SYDNEY WESTERN CITY PLANNING PANEL

REPORT: SWCPP Report

SUBJECT: 30 Broomfield Street, 64A Bareena Street and 30A Broomfield Street, Cabramatta

FILE No: DA 373.1/2021

Figure 8 – Eastern Elevation - view from eastbound traffic lane in Bareena Street.

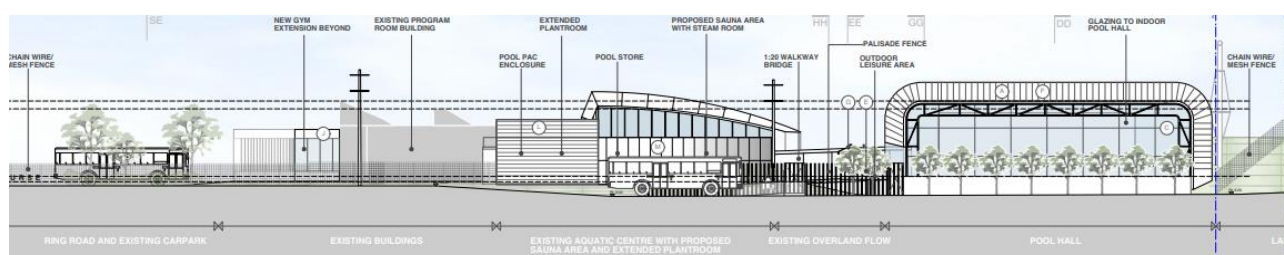
It should also be noted that the landscape plans do not appear to match the architects' perspectives for the east elevation perspective (street view from Bareena Street This perspective)indicates trees and screen planting, however the landscape plans show only screen planting.

It is recommended, at a minimum on this east elevation the landscaping shown within architects' perspective be included, this includes low to mid height screen planting and medium to large scale street planting.

Comment: The landscaping plan should be deferred to as the reference for landscaping.

The landscape plans show a hedge of 50 *Acmena smithii* 'DOW30' PBR Sublime. These species have a mature height of 5m with a spread of 2-3m and are cultivated as a hedging plant.

Taller tree specimens are not considered appropriate adjacent to the glazing, particularly eucalypts, for risk of damage to the glazing. The *Acmena smithii* as proposed are appropriate.
